TO: Building 532 (also referenced as 9532) Structural Repairs Bid Specification

SUBJECT: RFP NO. 071646

ADDENDUM NUMBER # 03

Photo 1: Temporary Shoring Location #1

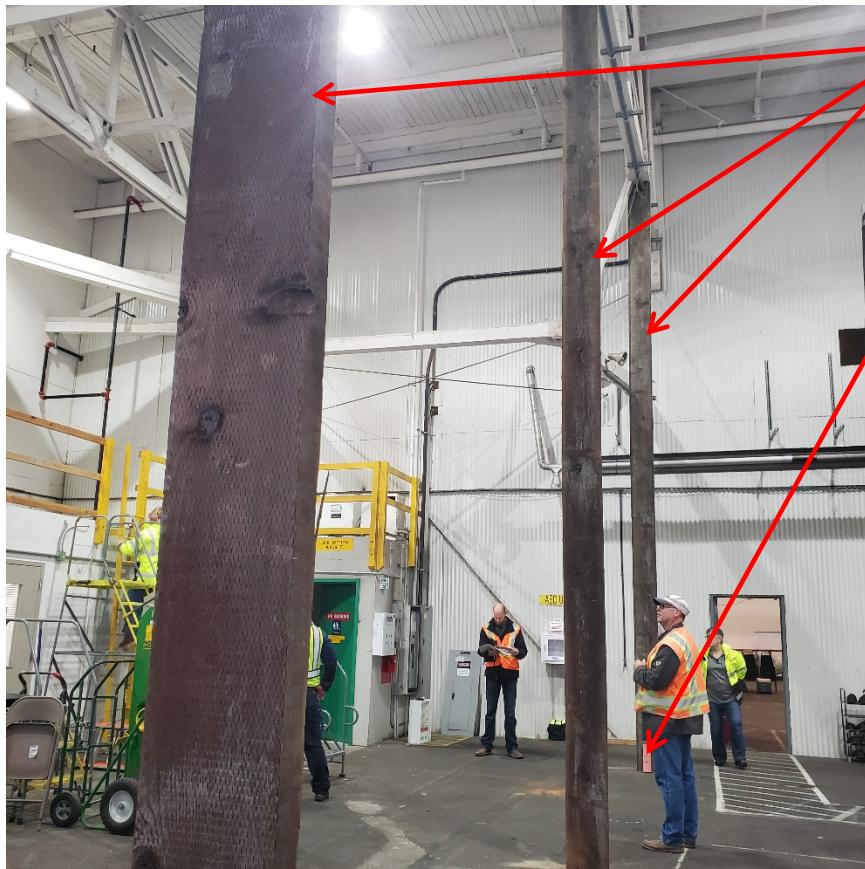
Question 1: Who is responsible for removing the existing temporary shoring?

Response 1: Contractor shall include the removal and of existing wood shoring columns at four (4) locations, refer to Photos 1 and 2. Coordinate storage onsite for pickup by Port of Tacoma maintenance personnel.

Remove 3 existing wood shoring columns along grid "G" between grids 7-9. Coordinate onsite storage and pickup with Port of Tacoma maintenance staff.

Remove existing post base and grind any penetrations flush to concrete.
